**Re: San Roque & La Sorena  
441 & 457 Coors Blvd. NW  
Conceptual Traffic Circulation Layout for DFT Approval  
Engineer's Stamp 10-04-23 (J10-D049)**

**RE: SAN ROQUE & LA SERENA  
441 & 457 COORS BLVD. NW  
TRAFFIC CIRCULATION LAYOUT - RESPONSE TO COMMENT**

**Traffic Circulation Layout**  
**c5.0**

## c7.1

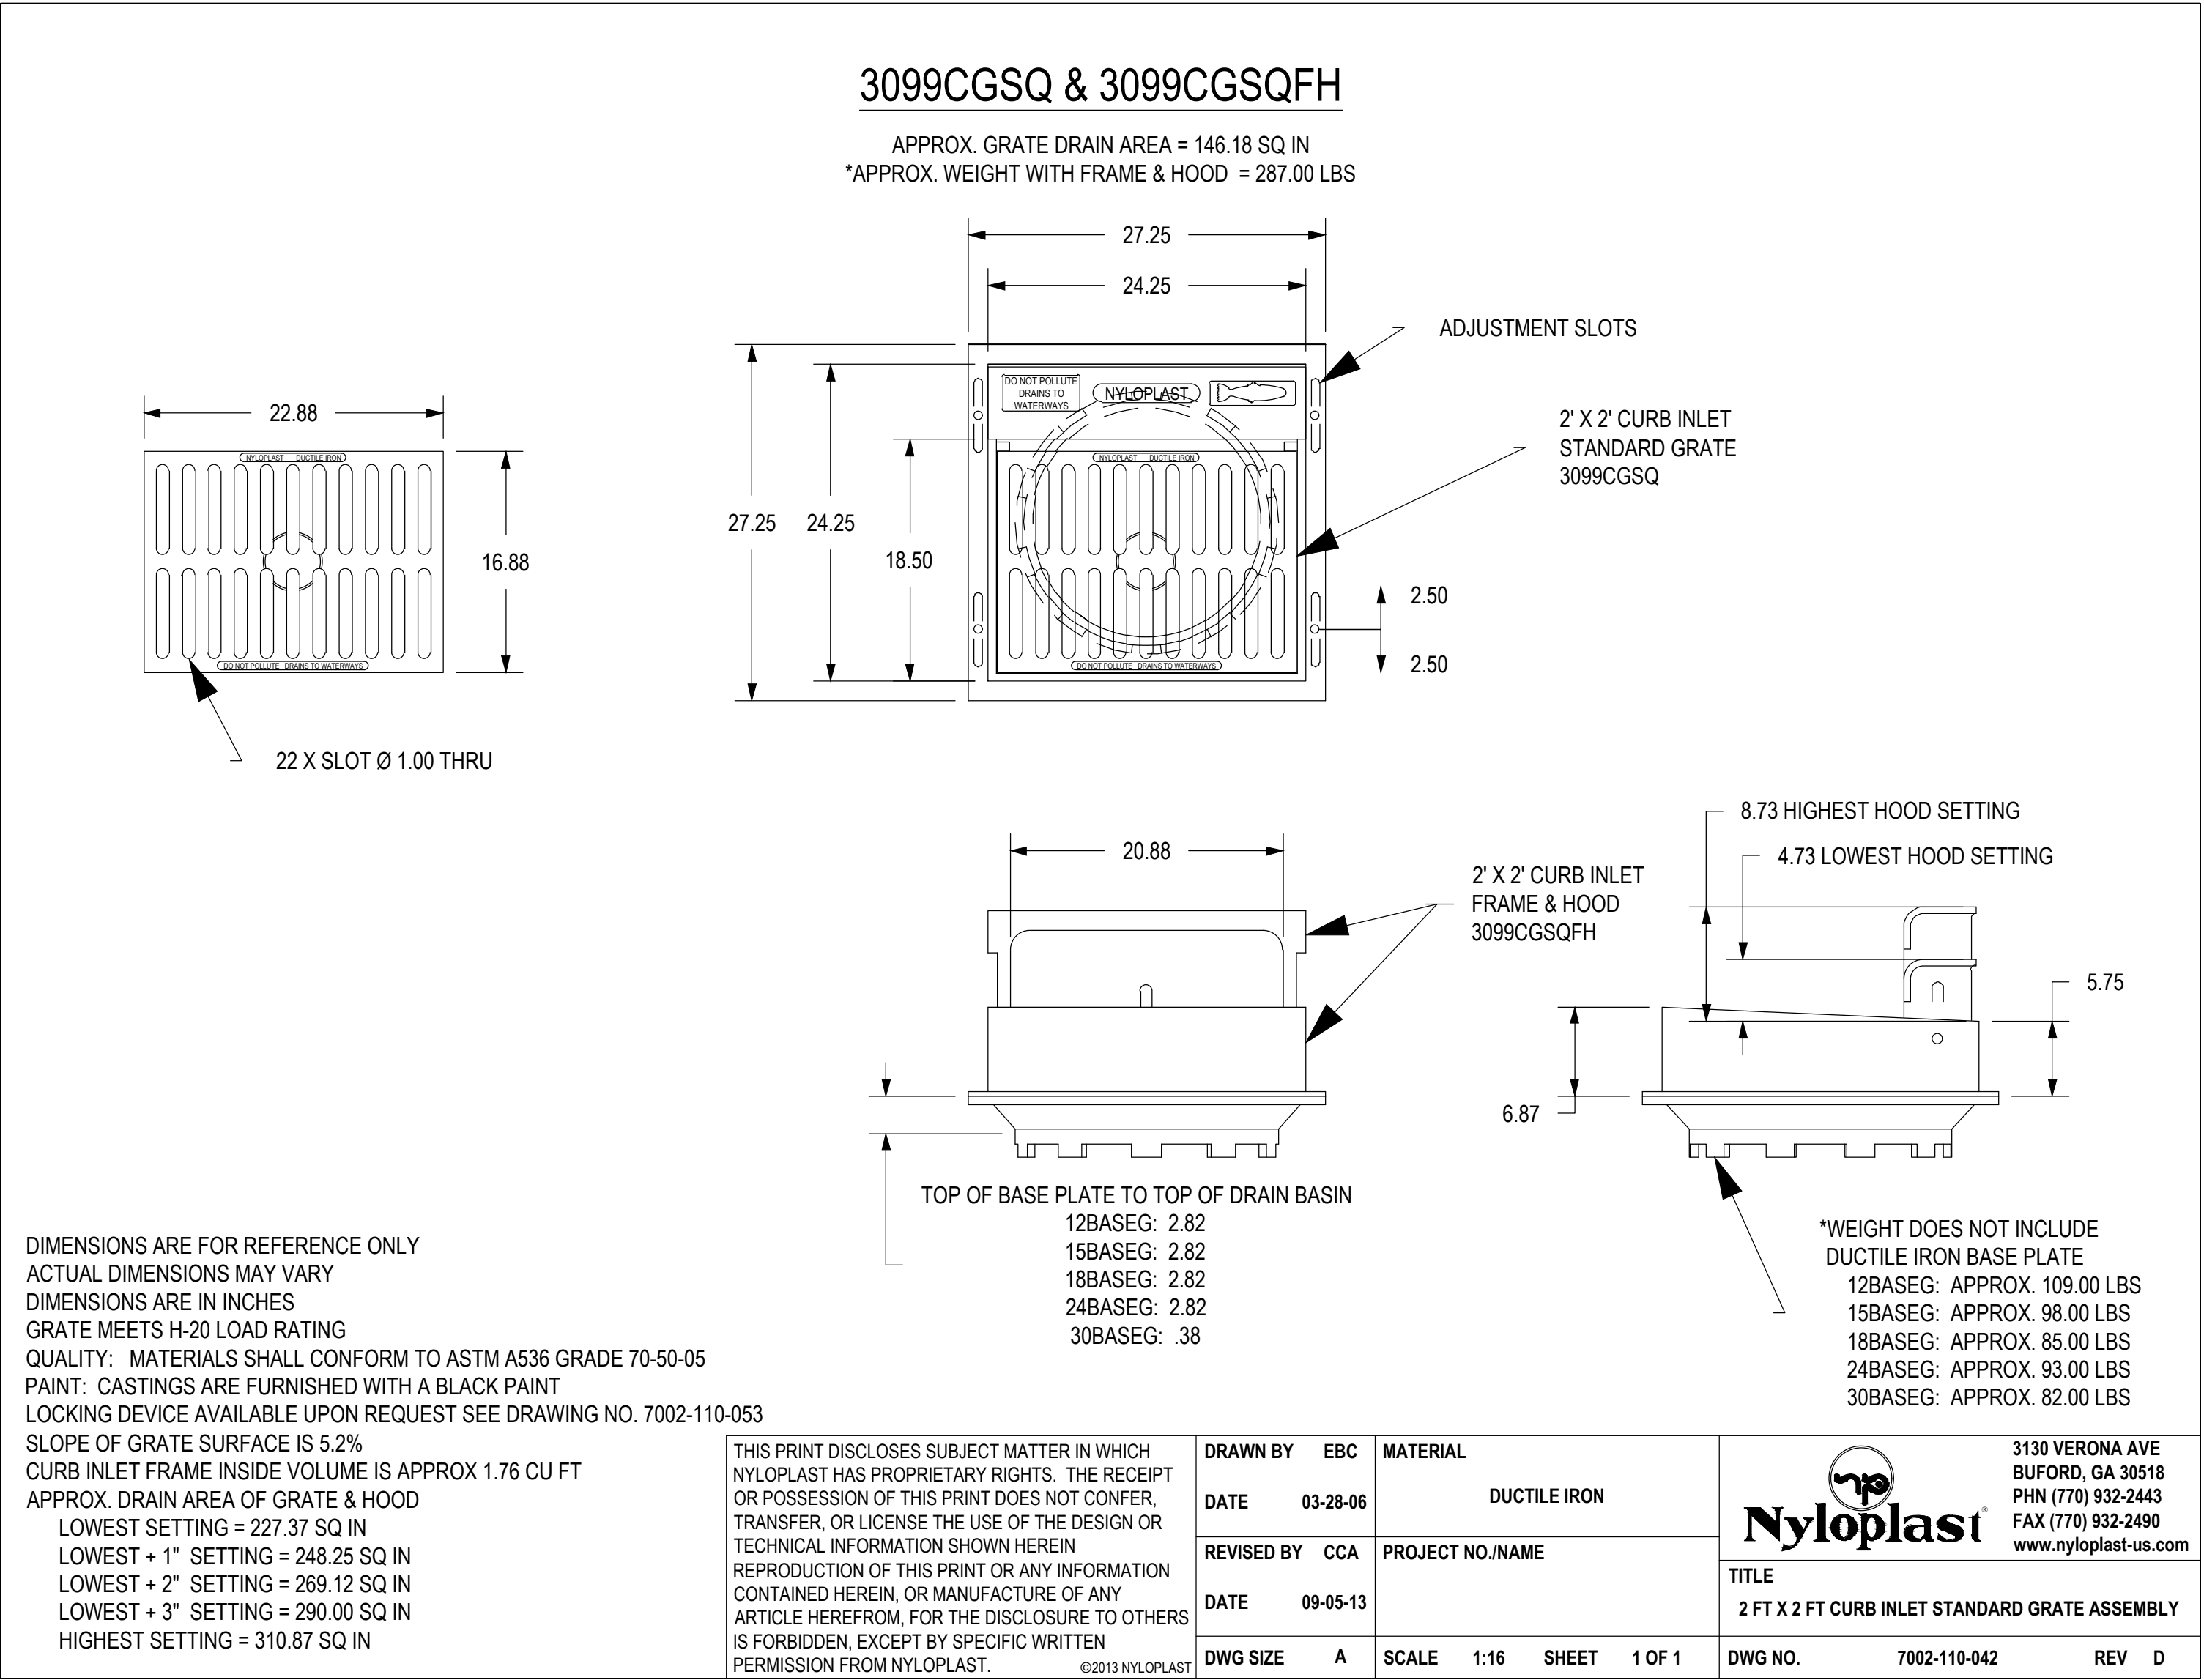
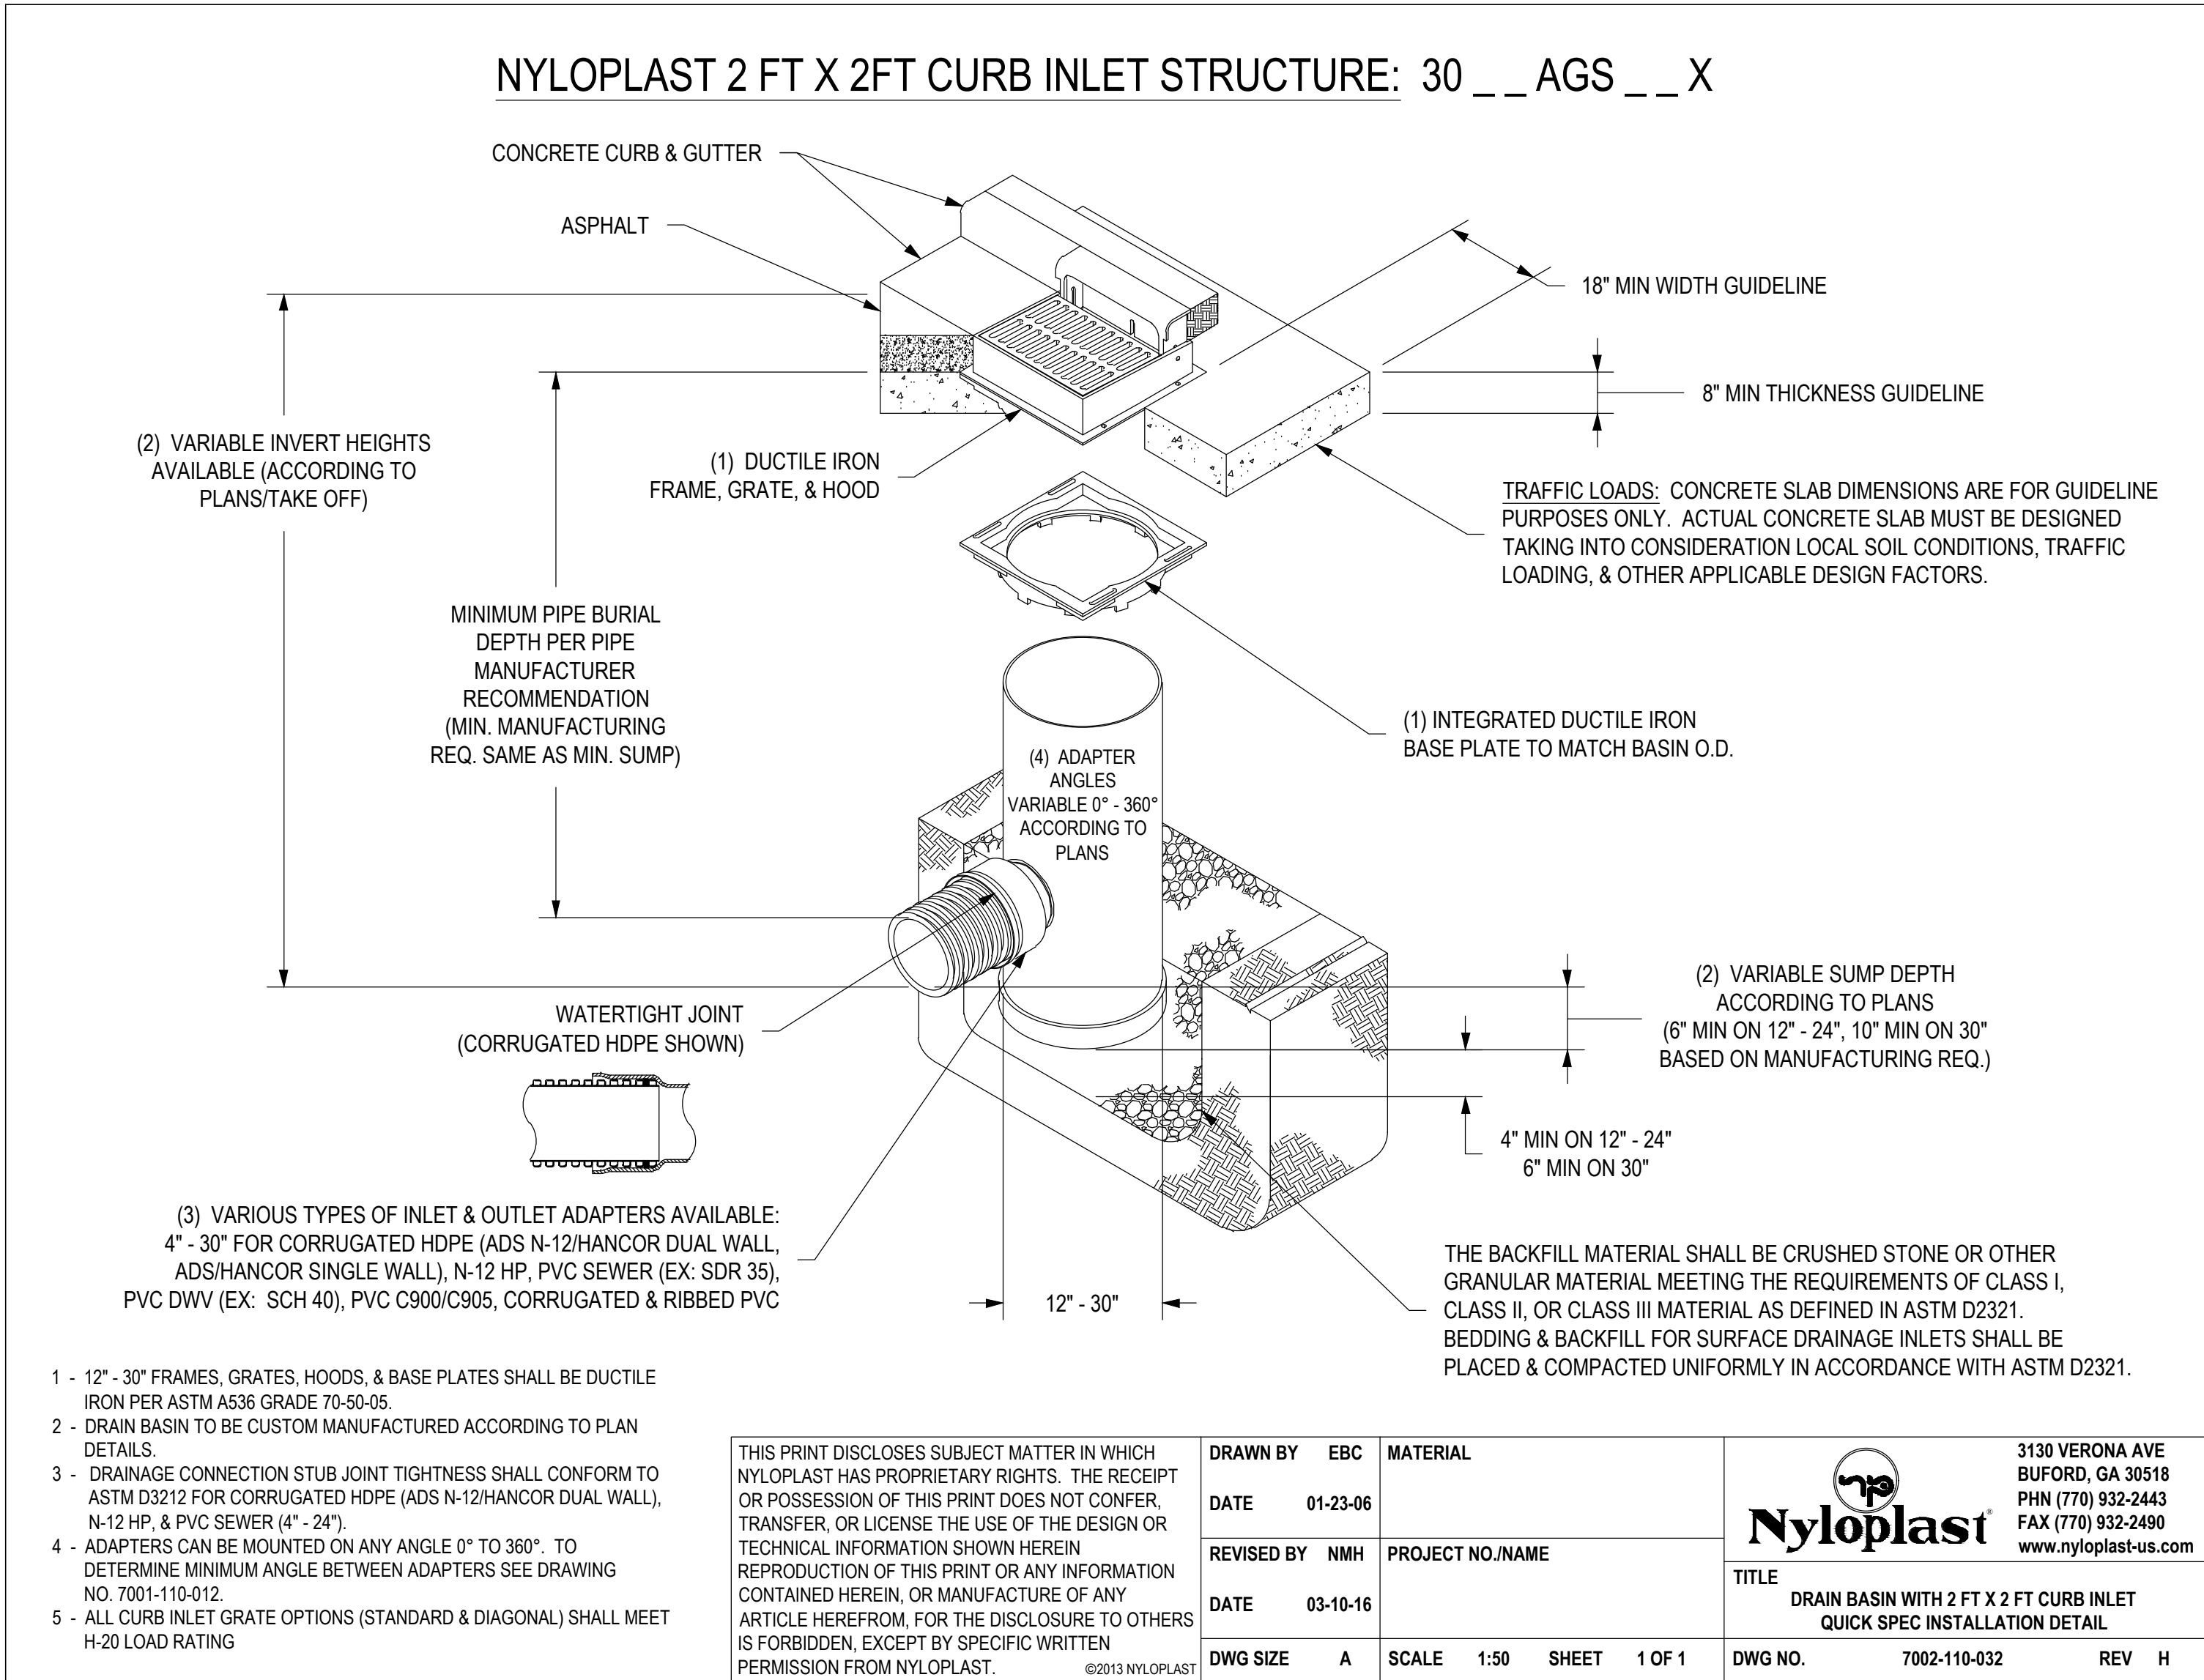
10. Please provide Bike Rack details. Details sheet C7.0 and C7.1 are missing.

11. All bicycle racks shall be designed according to the following guidelines:

**Response: Bike Rack details are shown on Sheet C7.0, which is now included in this resubmittal.**

**Response: The bicycle rack detail on sheet C7.0 meets all of these requirements.**

c6.0

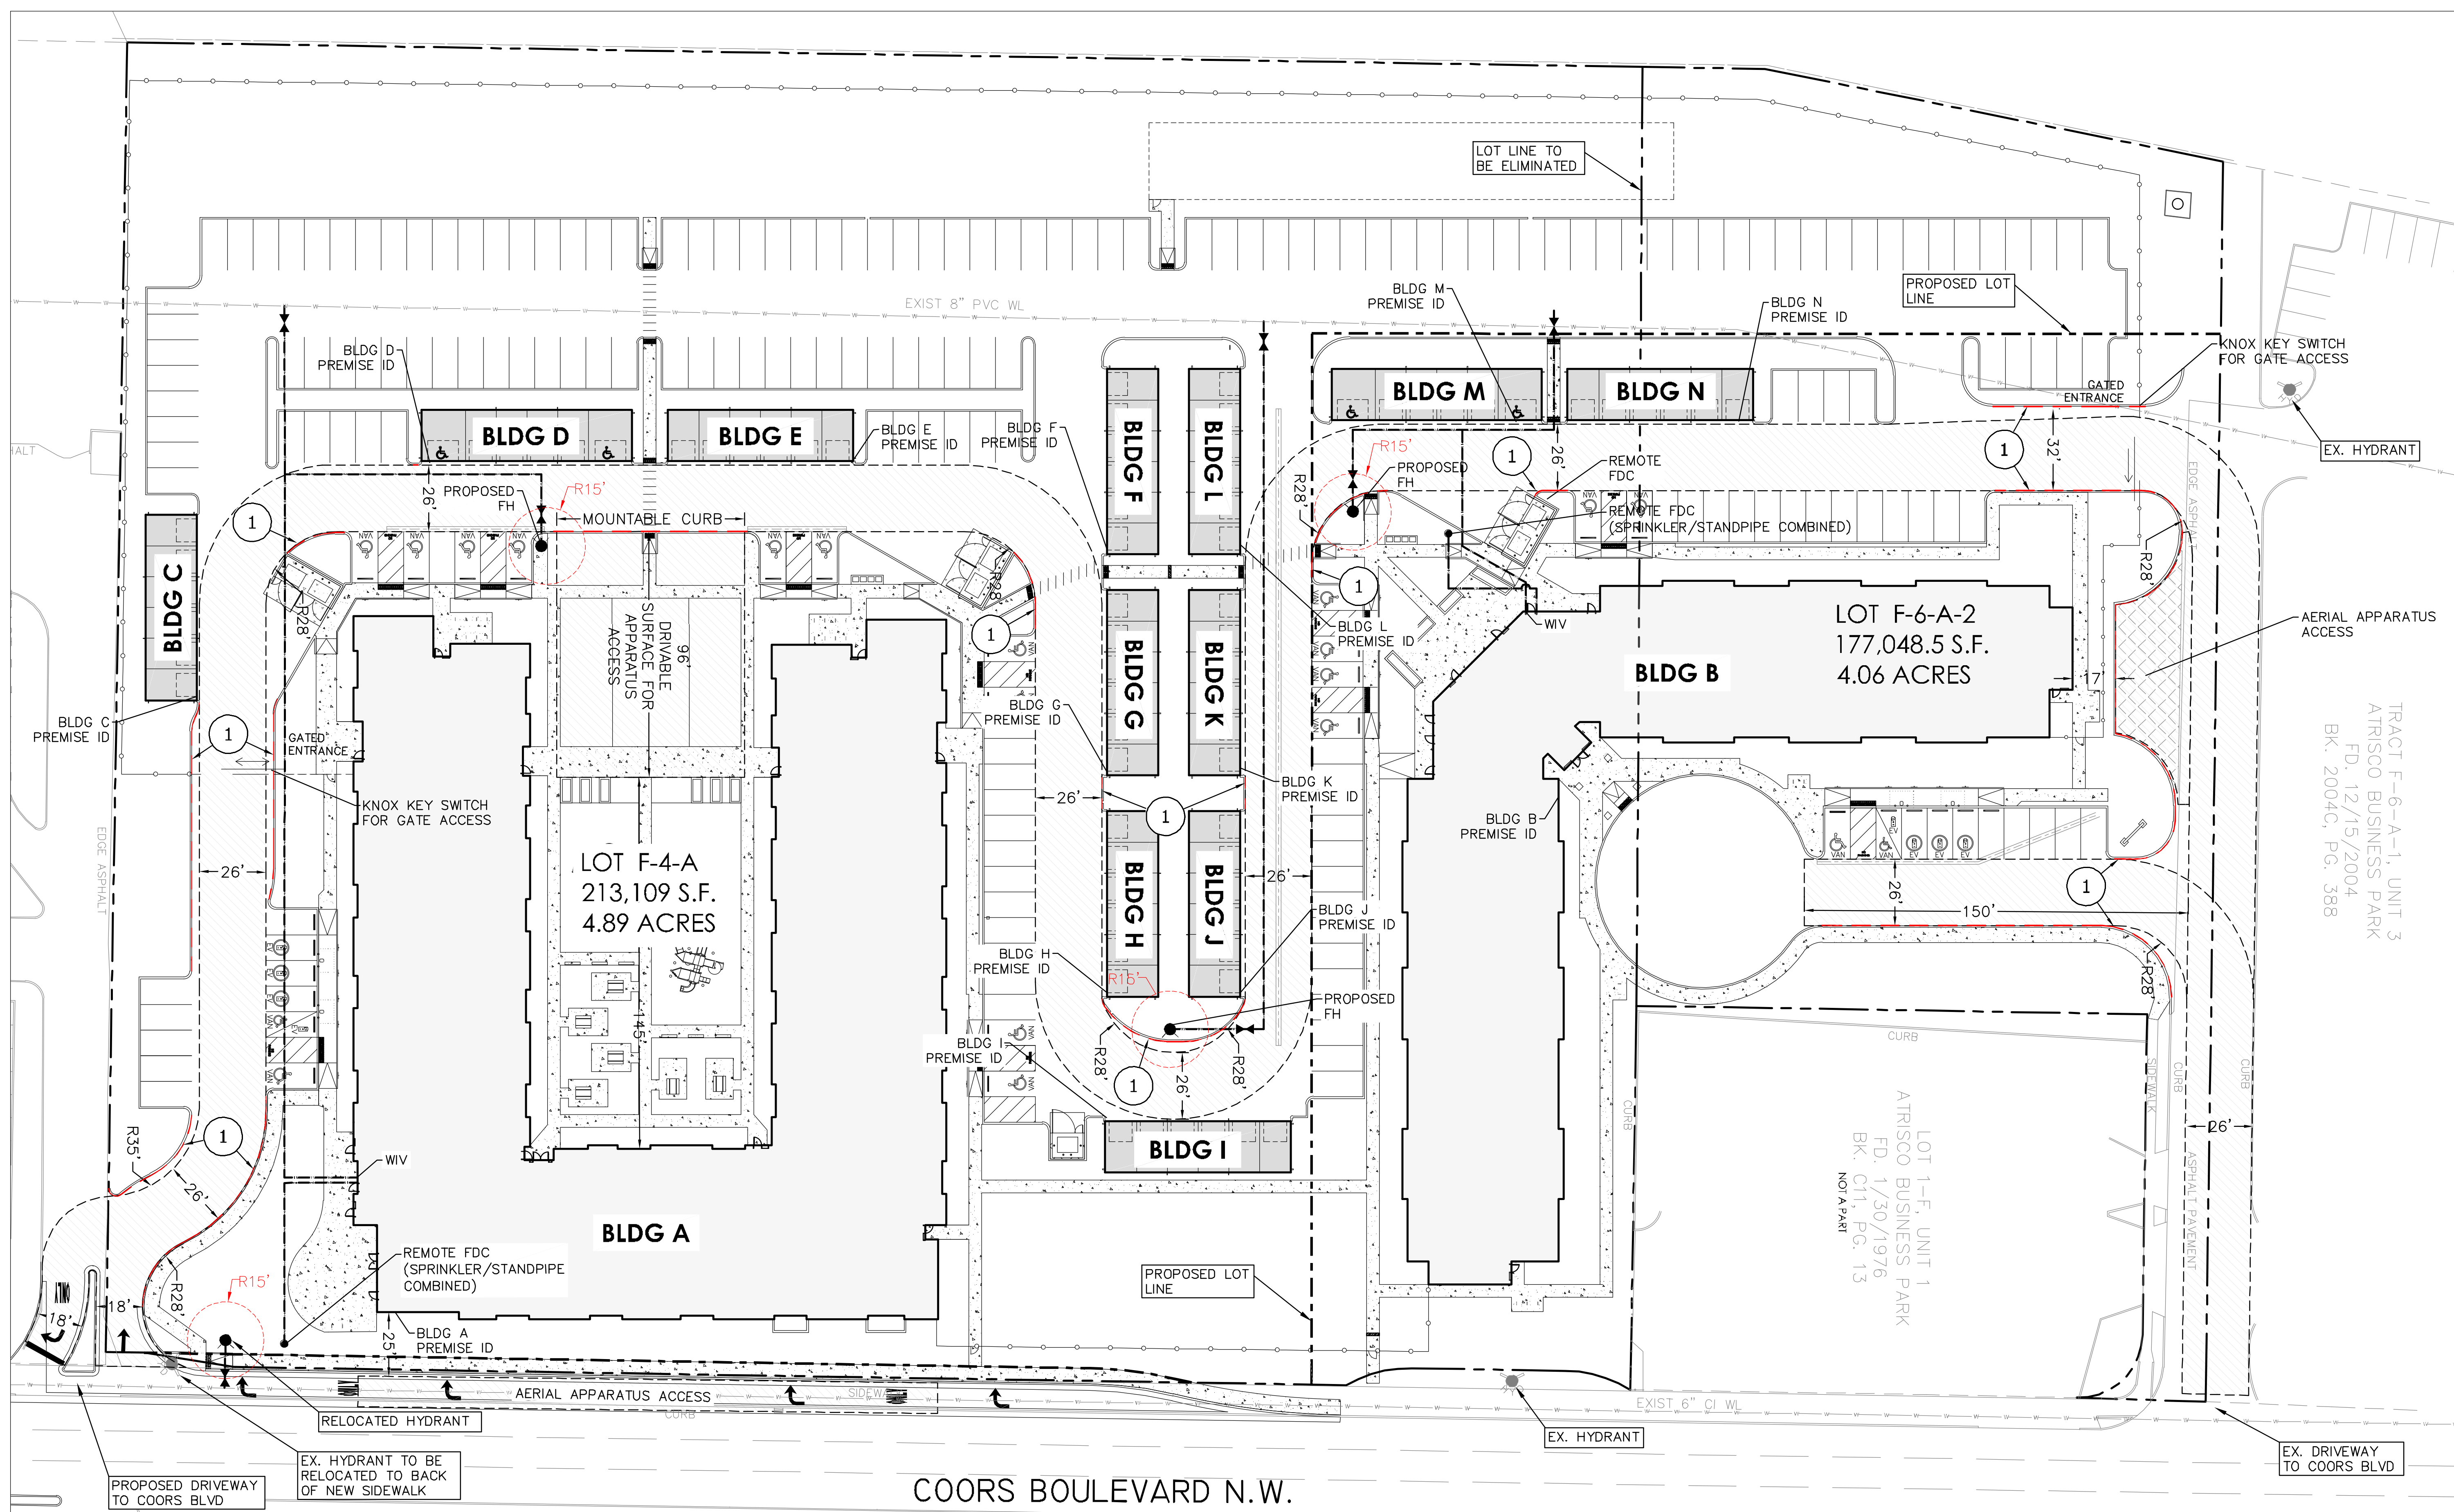
**Response: Sheet C1.0 is provided in this resubmittal with a solid waste approval signature for the refuse locations.**
19. Provide a copy of Fire Marshal approval.

**Response: Sheet C6.0 Fire 1 Plan is provided in the resubmittal with Fire Marshal approval stamp.**
20. It is not apparent what type of pavement surface is being proposed. A hard driving surface will be required as part of this proposed project for parking area and drive aisles.
